GRANDVIEW CONDOMINIUM COMMUNITY

PROJECT: 12023-0022/PS/P0203-0010
REVISION: Revision #7
RECEIVED: 8/14/2026
PLANNING & ECONOMIC DEVELOPMENT DEPARTMENT

**Subject: Grandview Development along Auburn Road,
Site Plan Review #7
Plans dated July 29, 2026
ASTI File No. P25-0125.33**

SITE PLAN .pdf Markup Summary

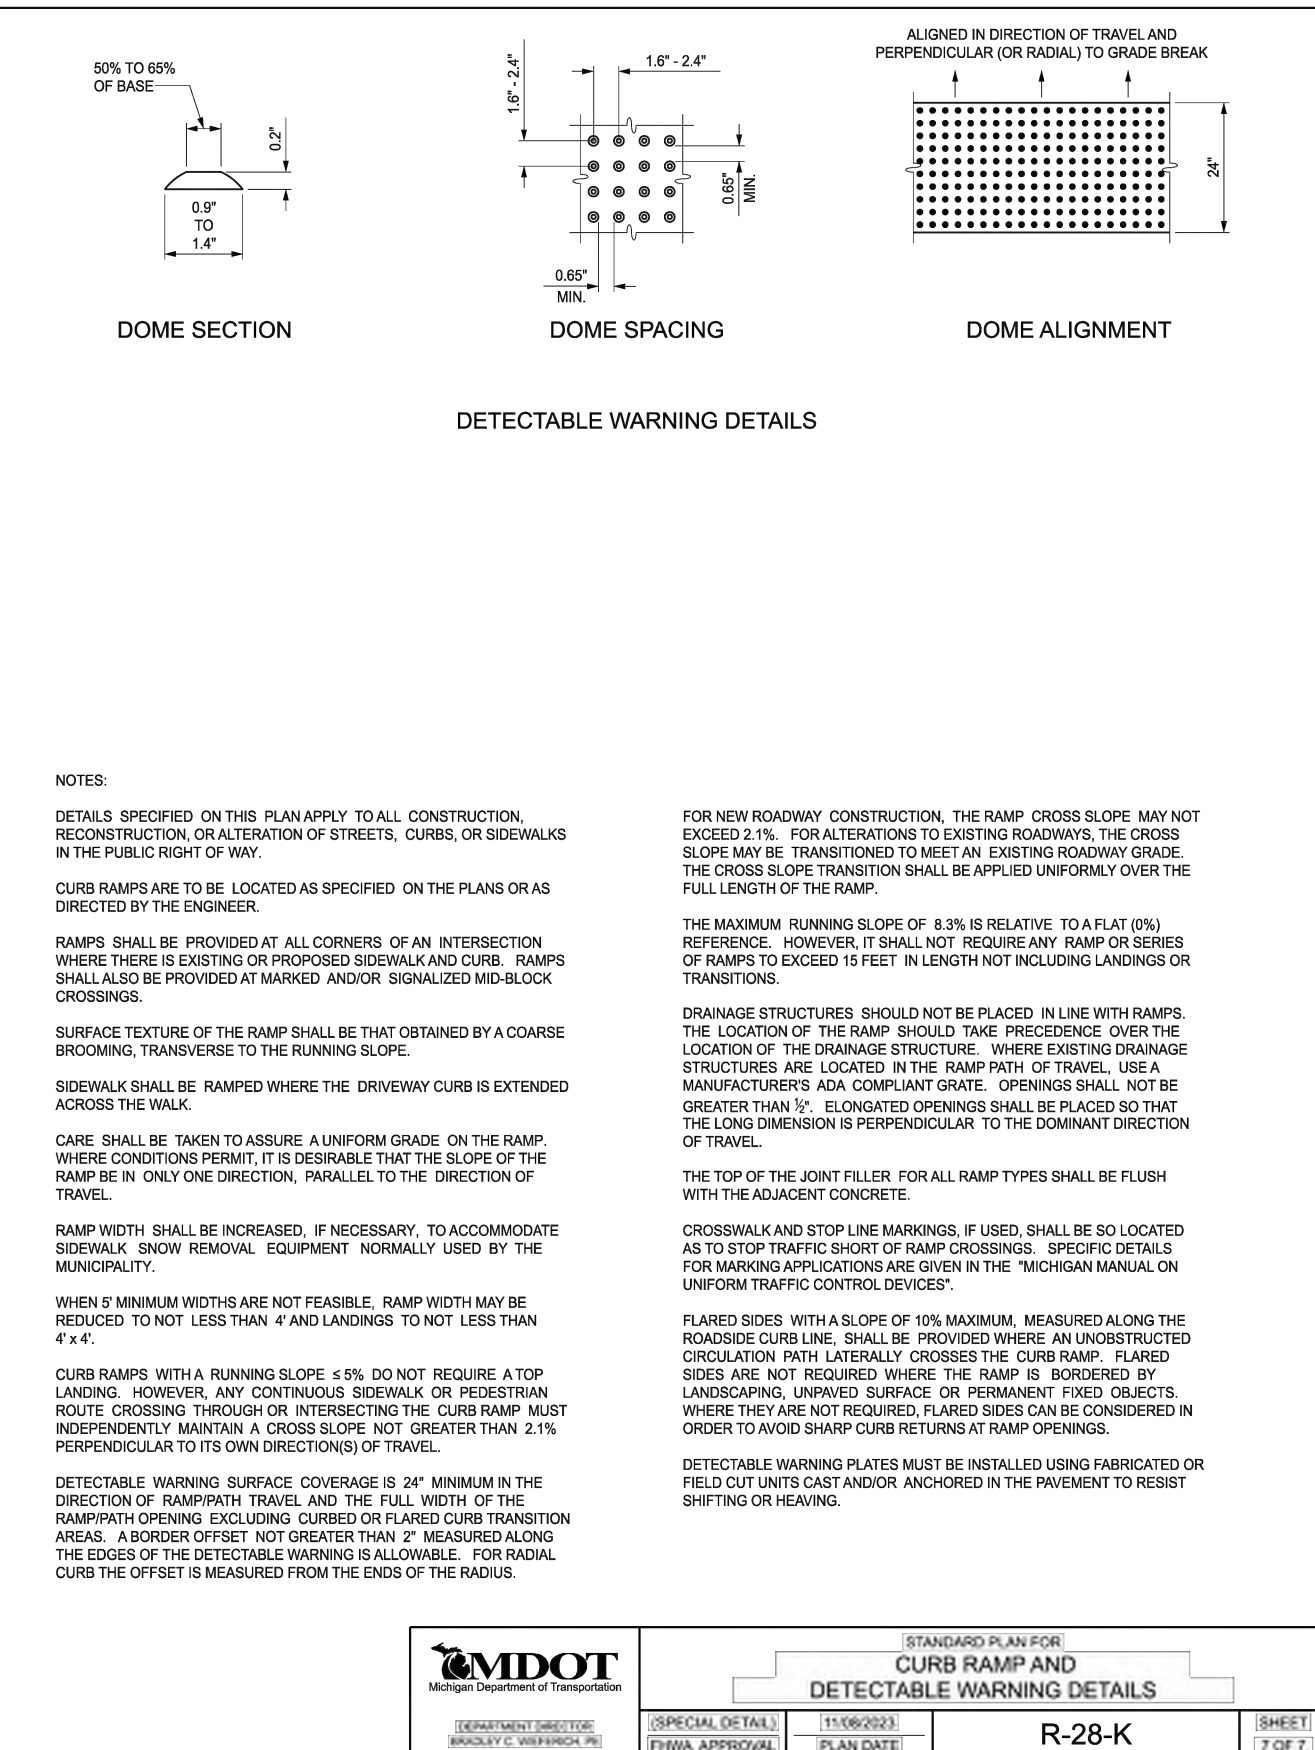
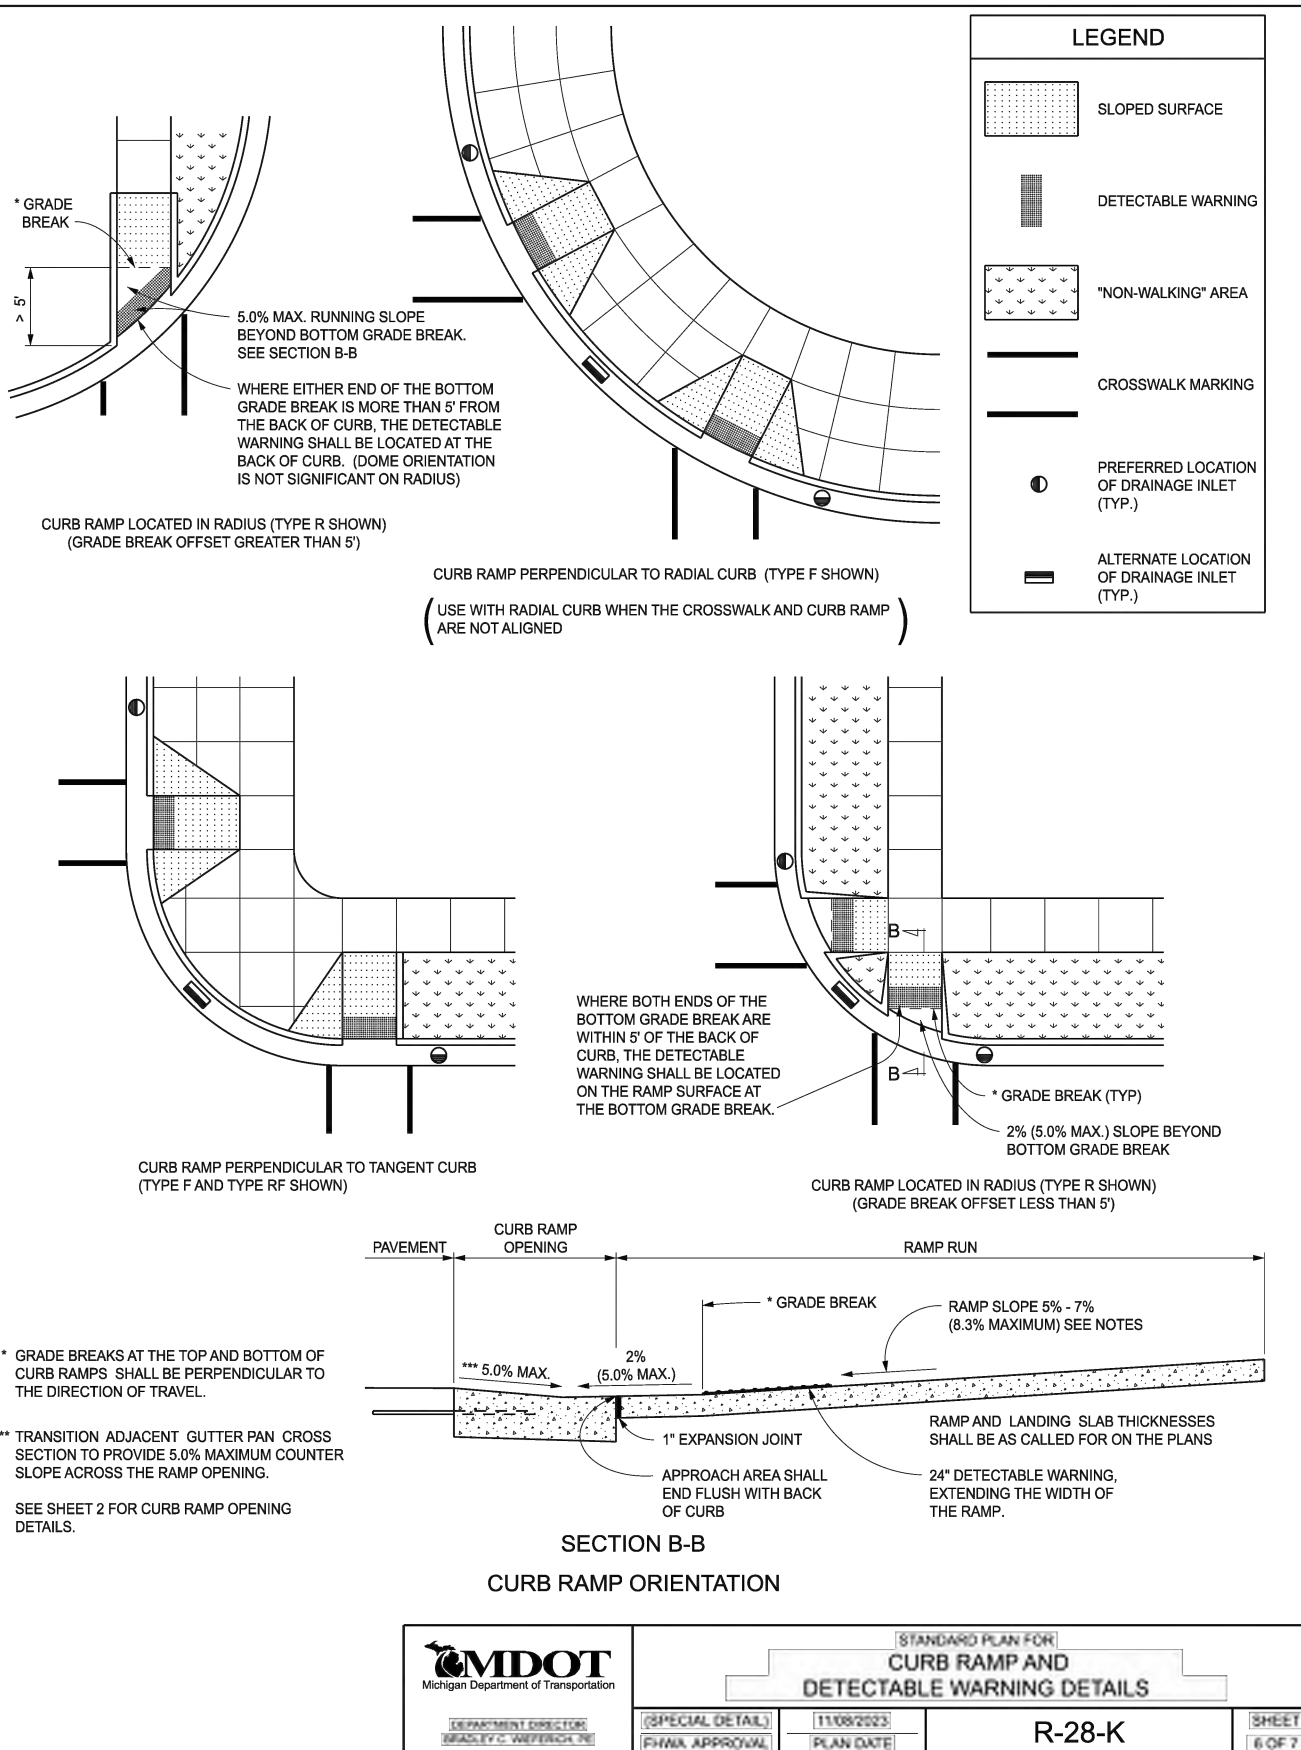
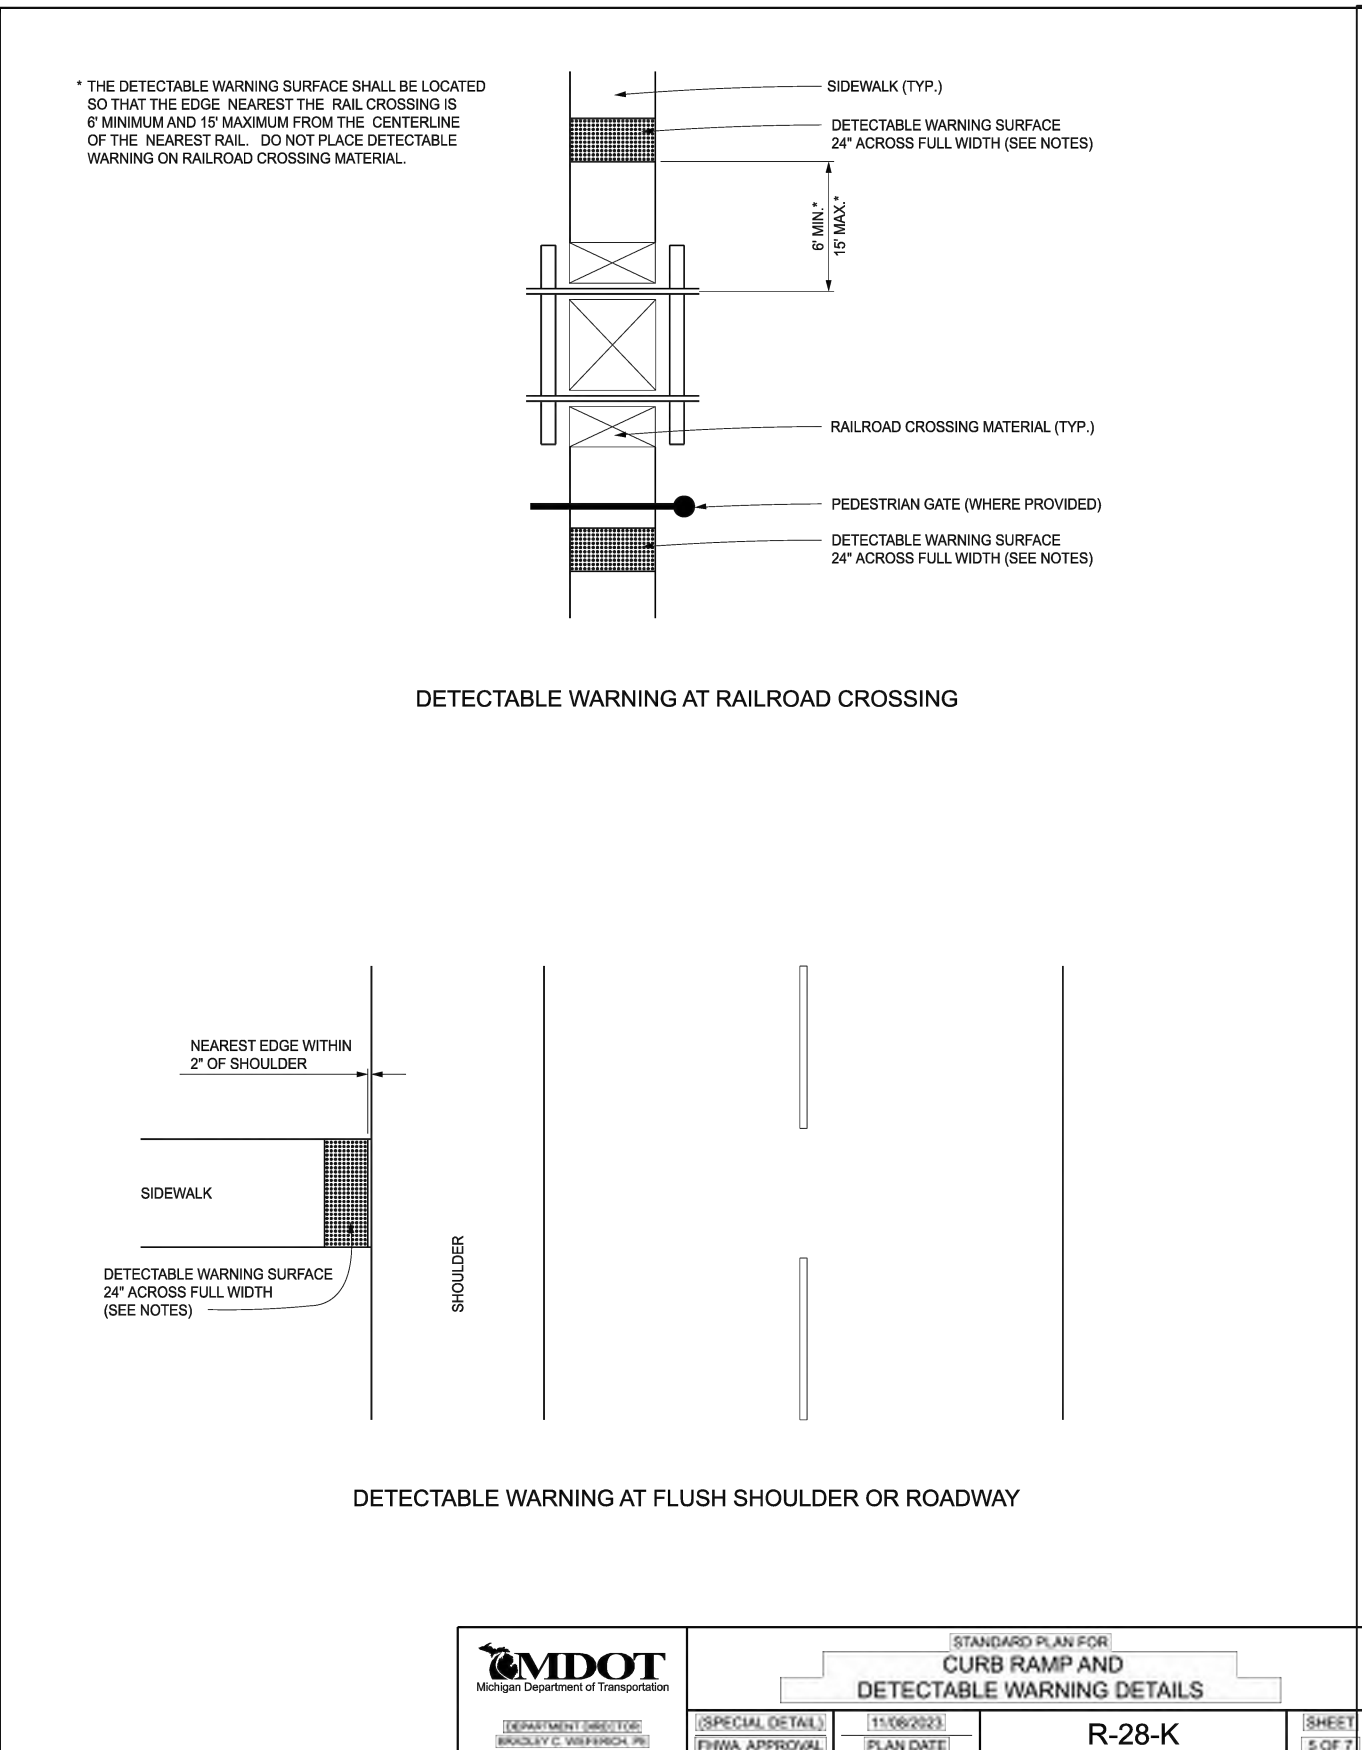
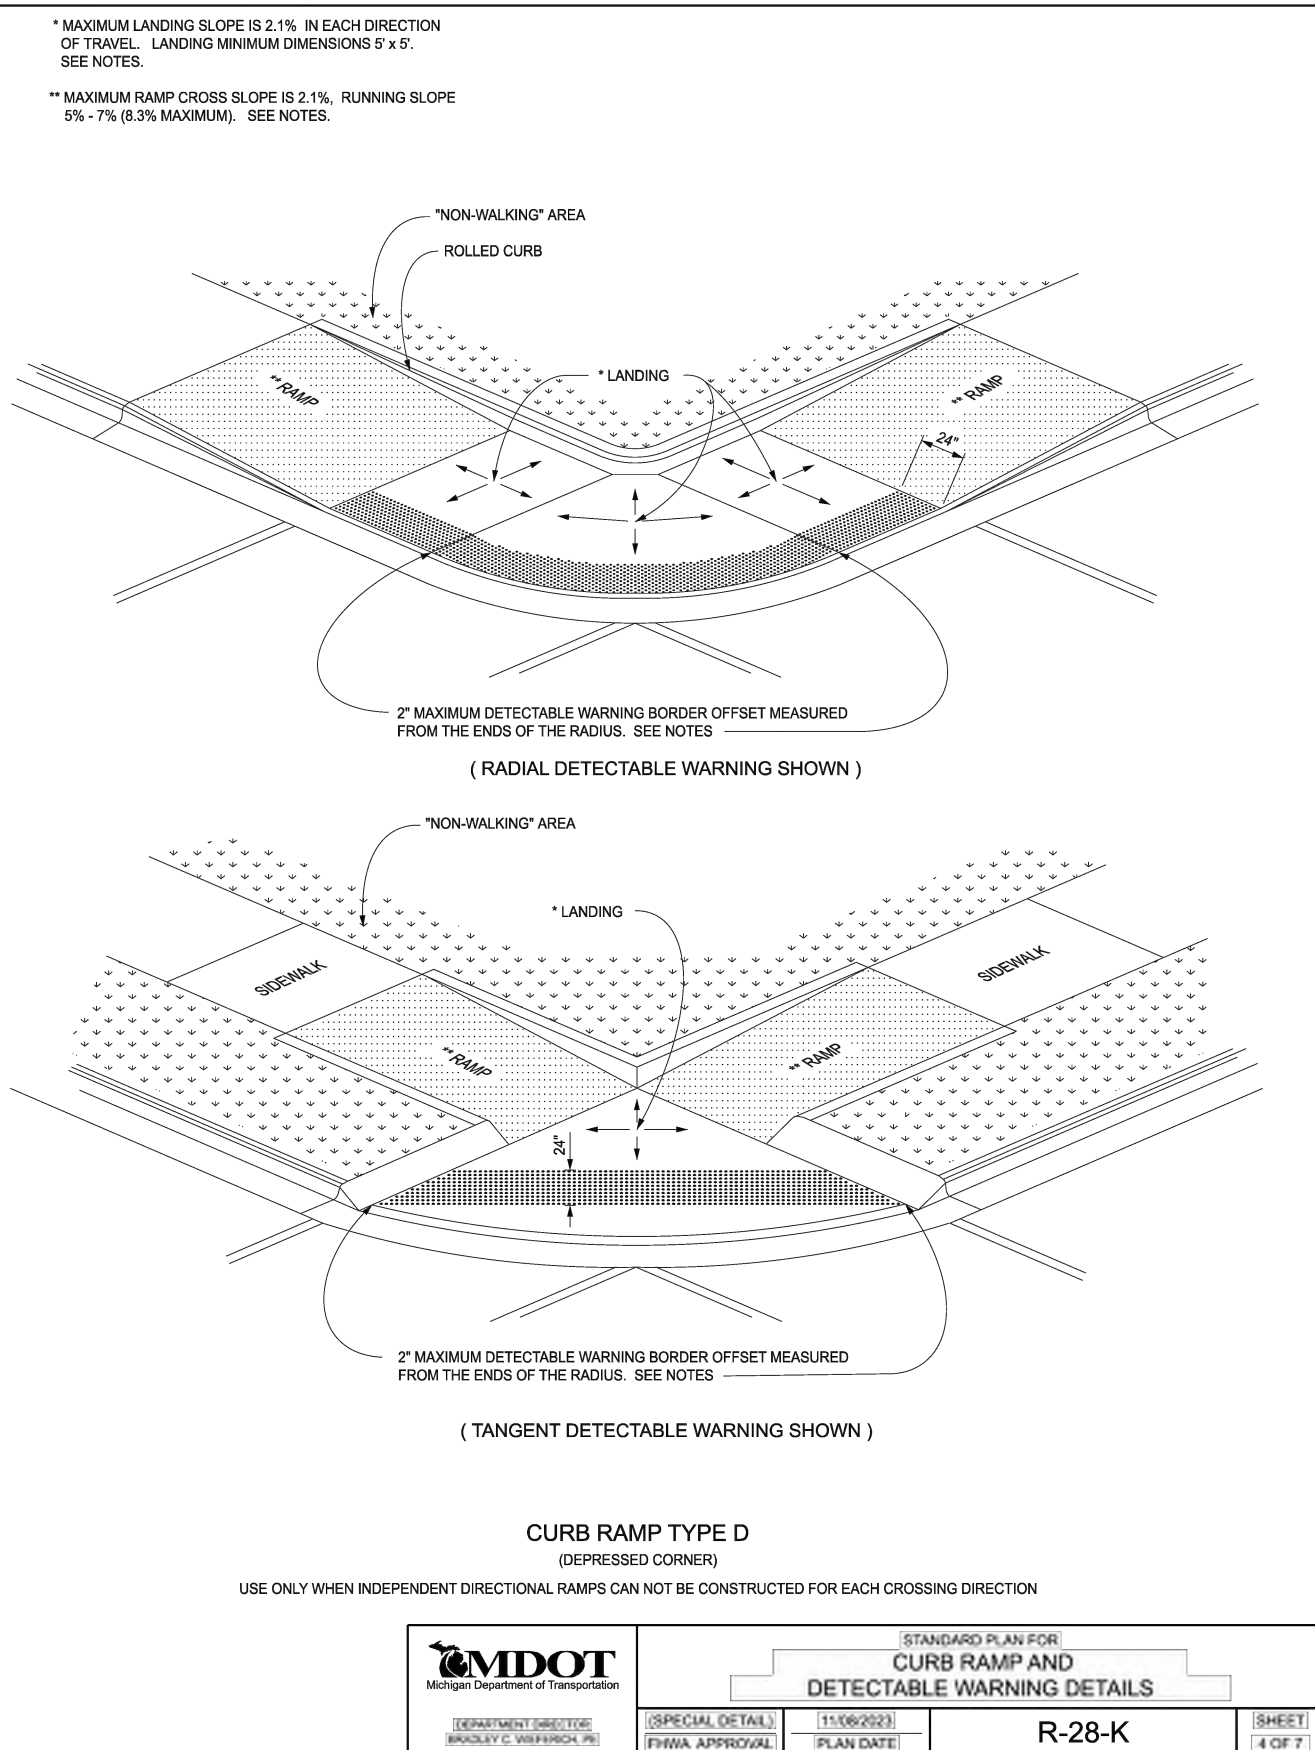
Add any crosswalk marking details here.
